Subject: Class 1 Permit Modification Notifications to the Waste Isolation Pilot Plant
Hazardous Waste Facility Permit Number: NM4890139088-TSDF

Class 1 Permit Modification Notifications

**Waste Isolation Pilot Plant
Carlsbad, New Mexico**

WIPP Permit Number - NM4890139088-TSDF

Figure F-1
Organizational Location of Training, Waste Handling, and Emergency Response Functions

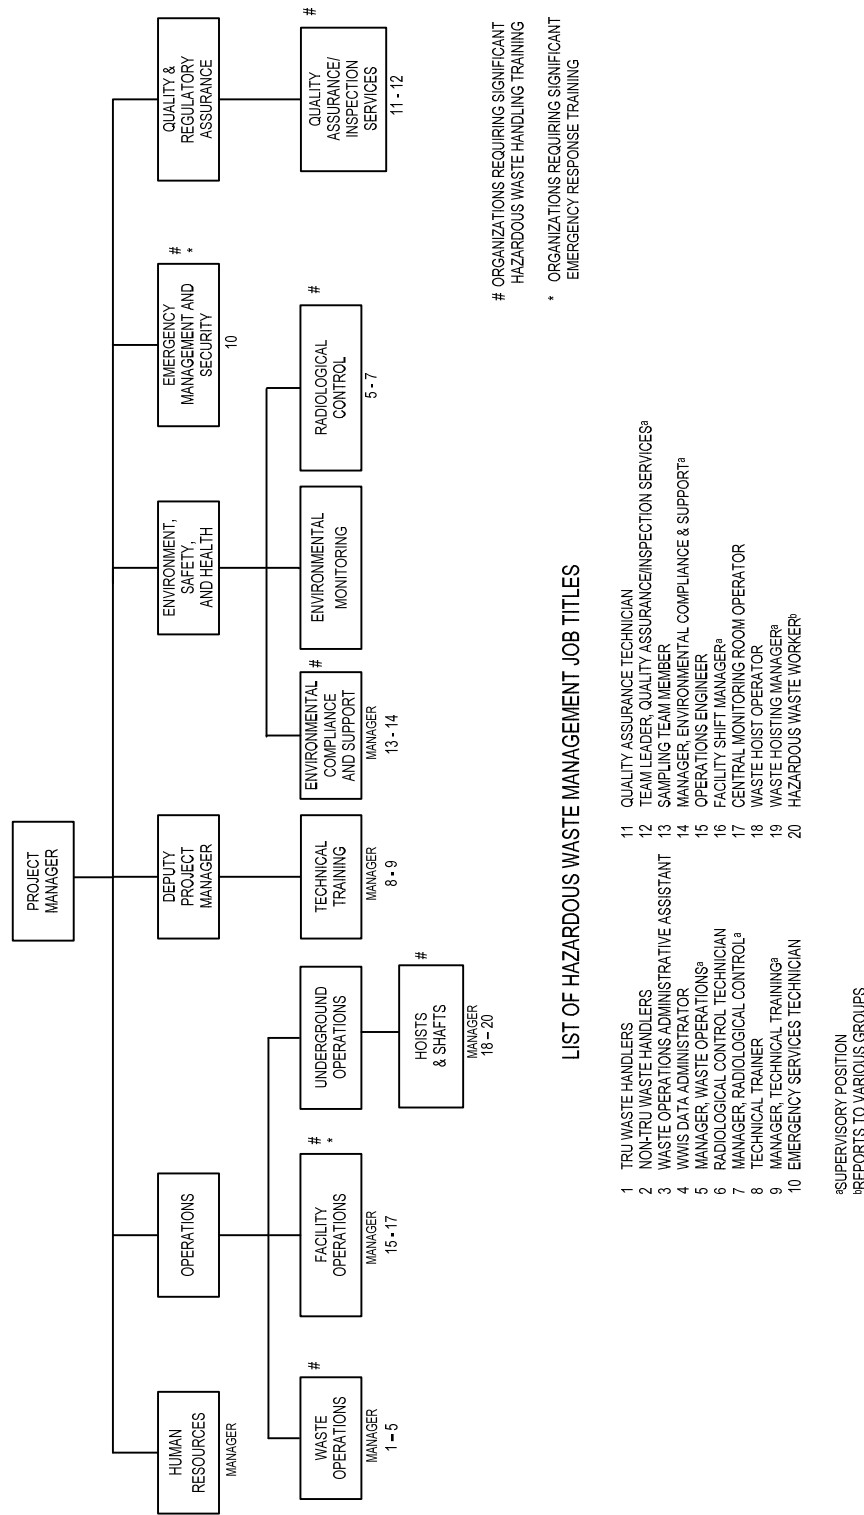
This modification revises Attachment F, Figure F-1, *Organizational Location of Training, Waste Handling, and Emergency Response Functions*, to change “General Manager” to “Project Manager” and to indicate that Technical Training is now reporting to the Deputy Project Manager. Attachment F, Figure F-1 is being revised to change “Emergency Management” to “Emergency Management and Security” and to indicate that this organization is now reporting to the Project Manager in lieu of Environment, Safety, and Health.

Figure A2-9
Underground Ventilation System Airflow

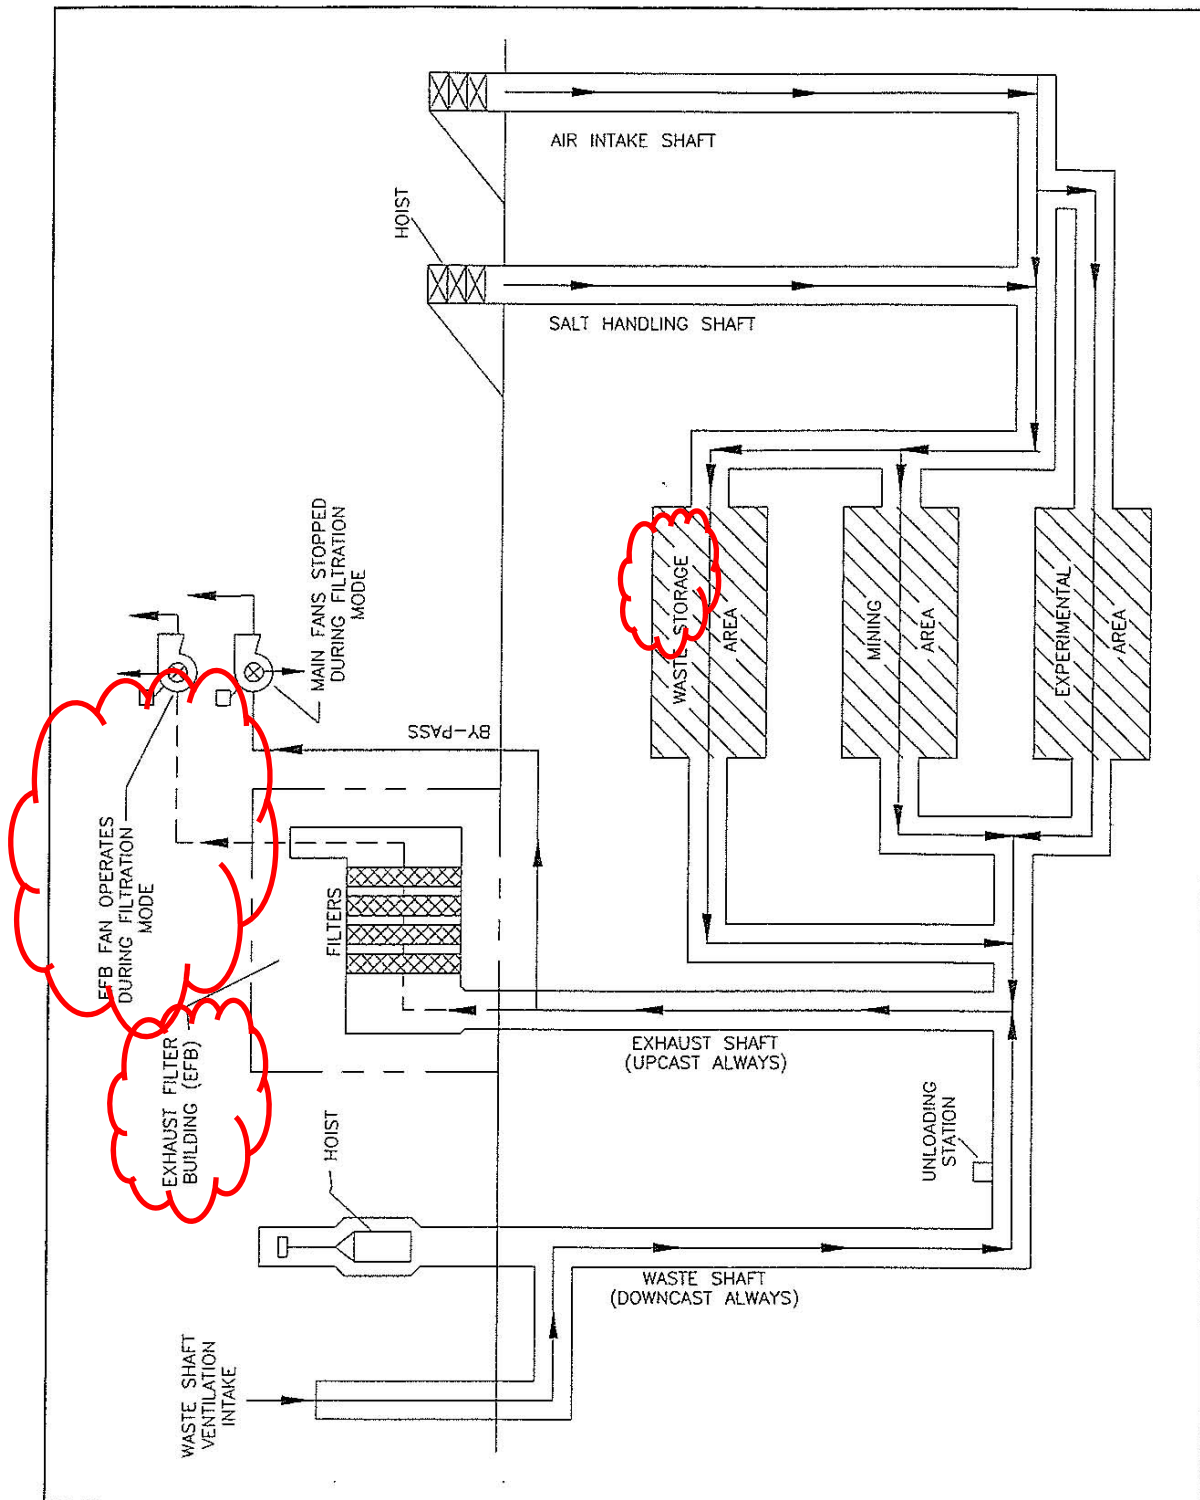
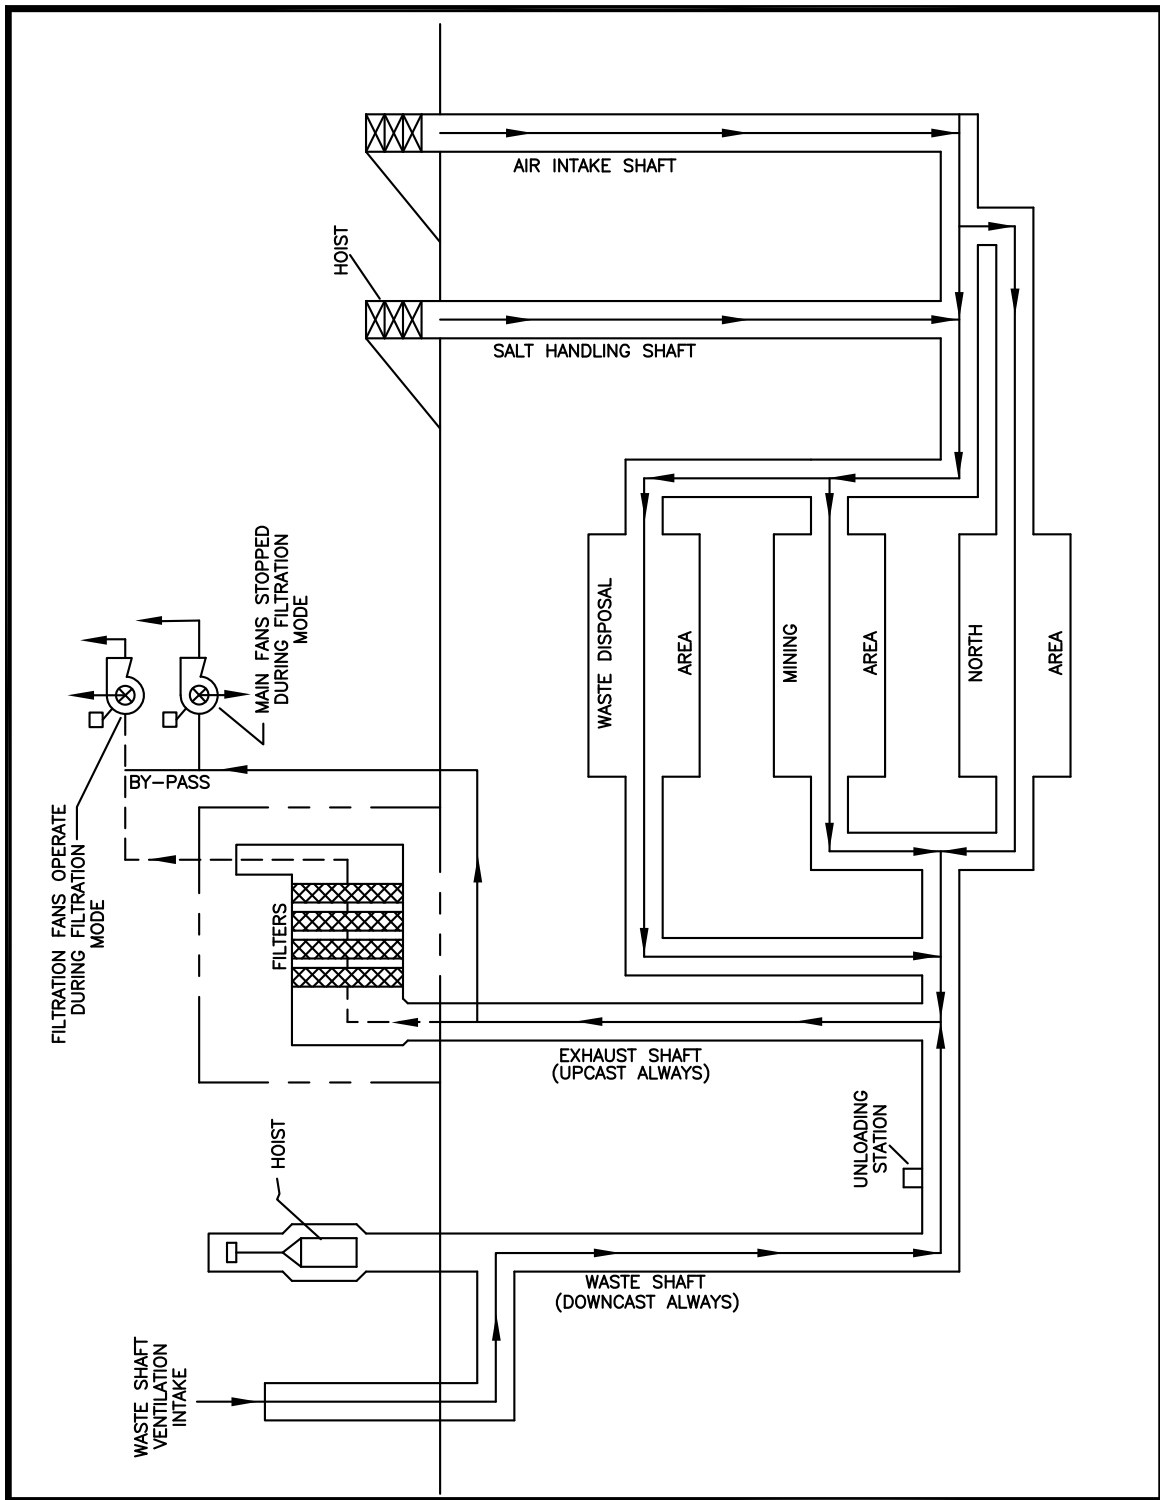
This modification updates descriptive language in the Permit sections, figures and tables listed below regarding the underground ventilation system to include the WIPP facility Interim Ventilation System (**IVS**):

- Attachment A2, Section A2-2a(3), *Subsurface Structures*
- Attachment A2, Figure A2-9, *Underground Ventilation System Airflow*
- Attachment A4, Figure A4-2, *WIPP Traffic Flow Diagram*
- Attachment D, Figure D-1, *WIPP Surface Structures*
- Attachment D, Figure D-1a, *Legend to Figure D-1*
- Attachment D, Figure D-6, *Fire-Water Distribution System*
- Attachment D, Figure D-8, *WIPP On-Site Assembly Areas and WIPP Staging Areas*
- Attachment O, Table O-1, *Ventilation Operating Modes and Associated Flow Rates*

the underground. By design, the filtration system is limited to a net flow rate of 60,000 scfm of ventilation air. Because this flow rate is insufficient to support underground activities such as waste disposal and because the Permit requires a minimum of 35,000 scfm in the active disposal room when waste handling is underway, the IVS provides additional filtered ventilation air necessary to allow TRU mixed waste handling operations to resume. This upgrade has resulted in a revision to the configuration of the ventilation system by providing additional ventilation equipment and operating modes, and as a result, the descriptions in Permit Attachment A2, Section A2-2a(3), Attachment O, Table O-1 require revision. In addition, various figures are being revised to depict the IVS.

The changes to the Permit text include updates to text and figures that describe the WIPP facility underground ventilation system, including a description of the IVS. The Permittees submitted a notification of planned alteration to the permitted facility to the NMED on August 26, 2014, describing this system. Consistent with this notification the NMED will be provided with the New Mexico Professional Engineer's certification of the installation and be afforded an opportunity to inspect.

Figure D-6
Fire-Water Distribution System

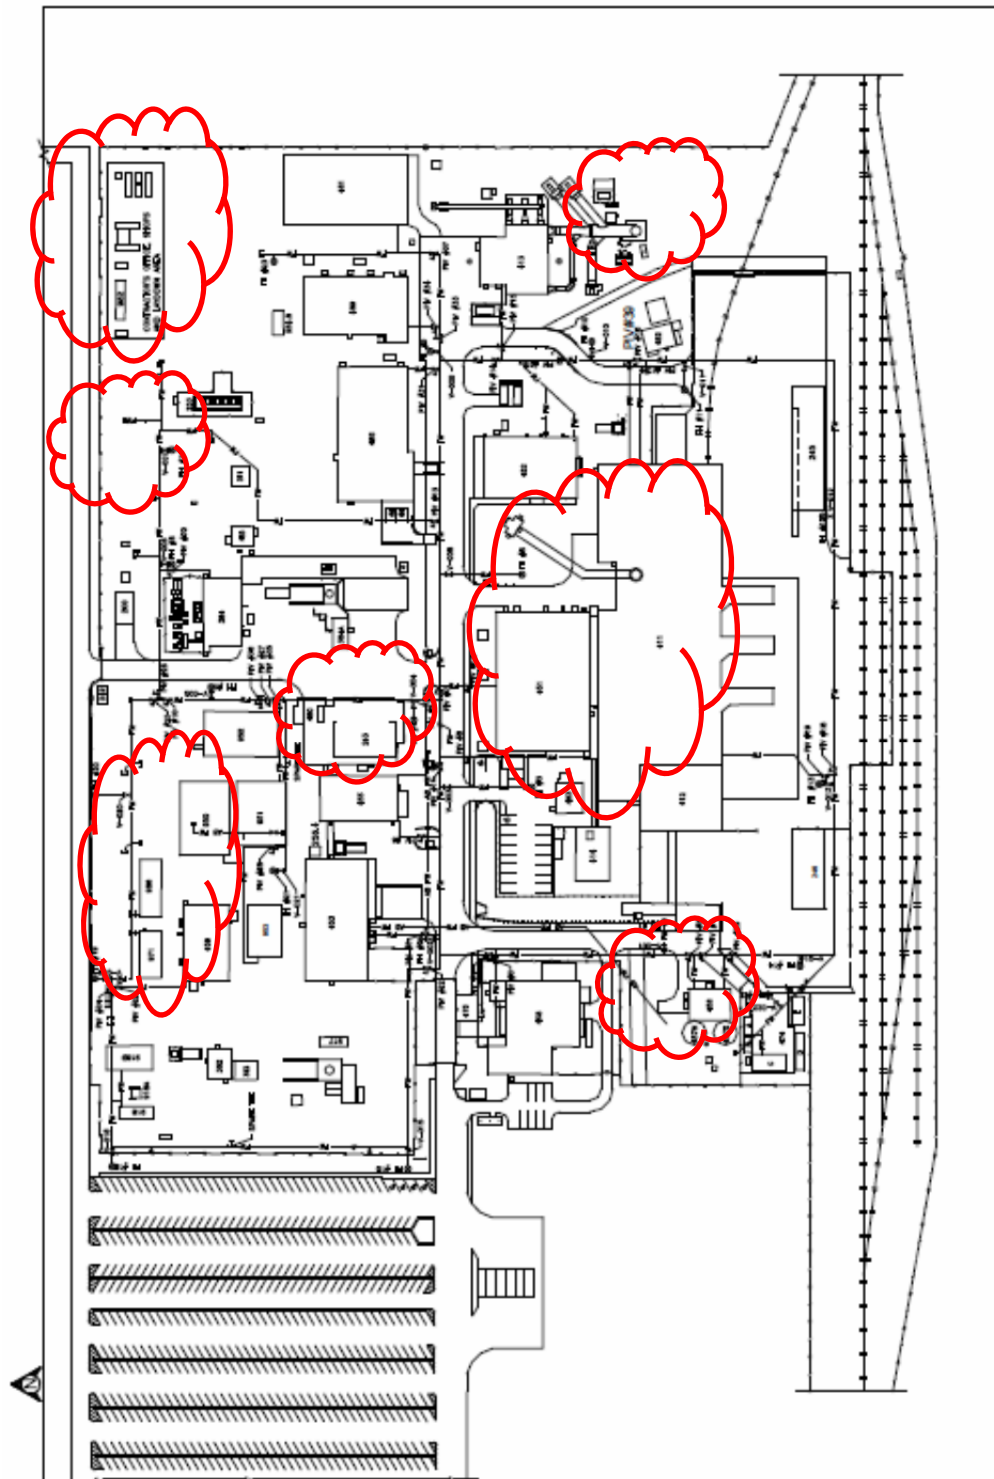
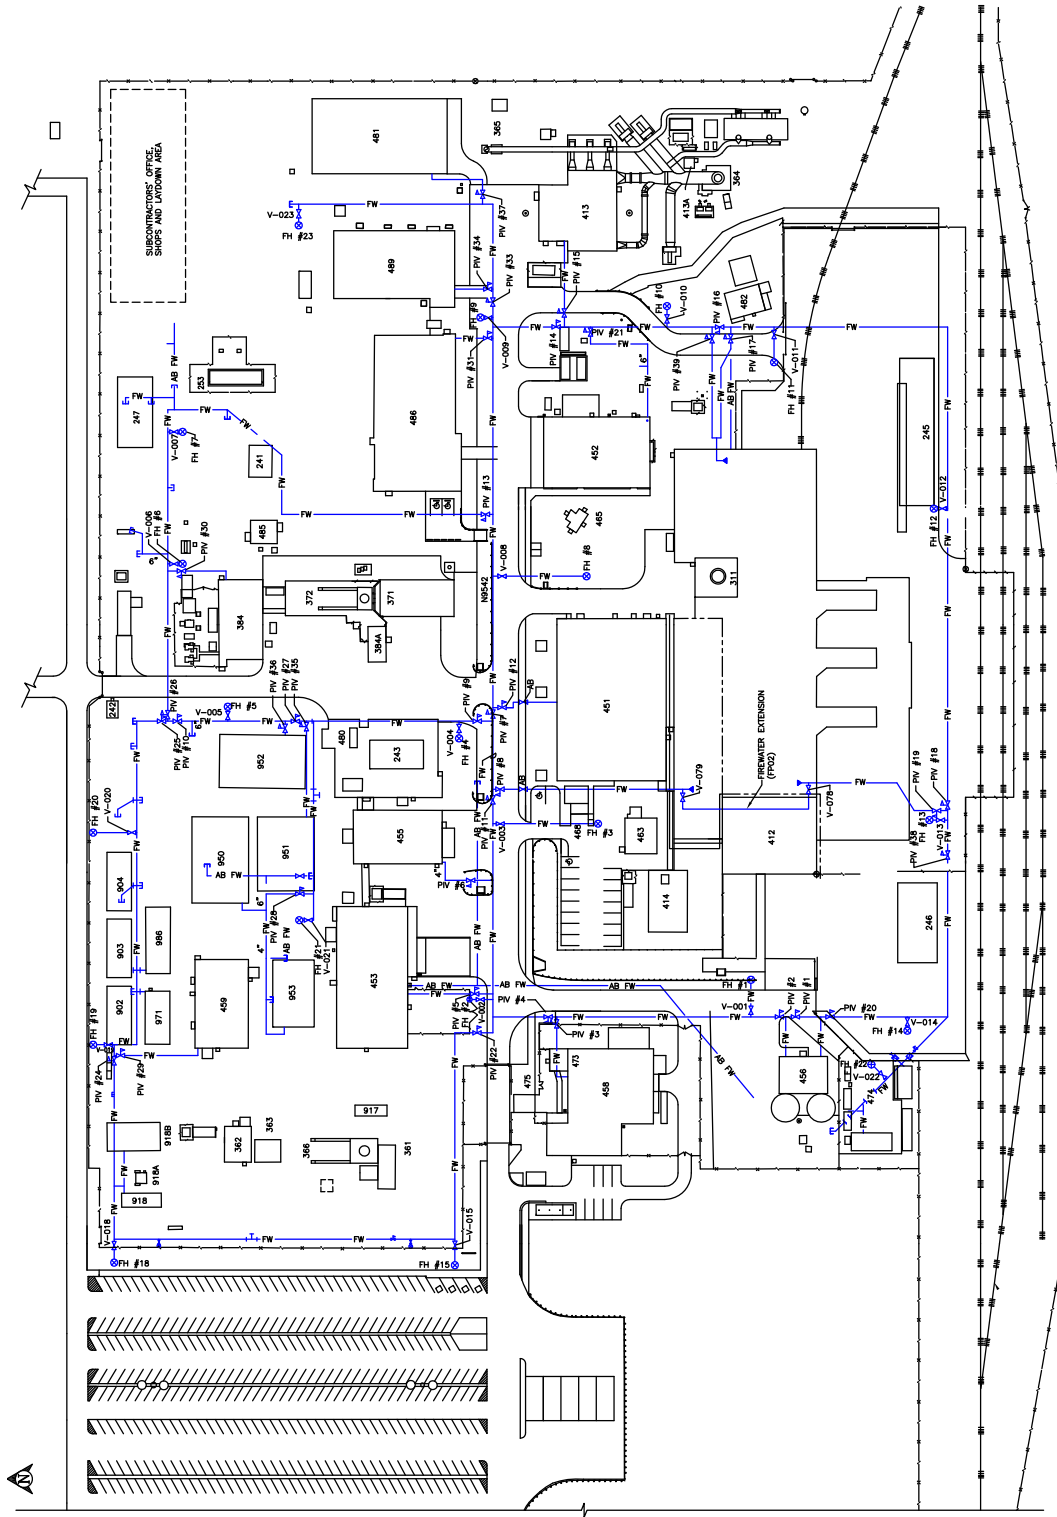
Editorial changes are also being made to the Permit text to correct some typographical errors and to clarify existing text. For example, a parenthetical is being added; “e.g.” is replacing “i.e.” in reference to availability of the main exhaust fans; “contaminants in the reduced exhaust flow” is being changed to “particulates” in reference to high efficiency particulate air (**HEPA**) filtration; and the Figures A2-9, A4-2, D-1, D-1a, D-6 and D-8 are being revised to include the new 900 series trailers, the north maintenance shop, and other additions and/or deletions of surface facilities. These changes to the figures are identified with “clouds” which indicate the additions and/or deletions of the surface facilities.
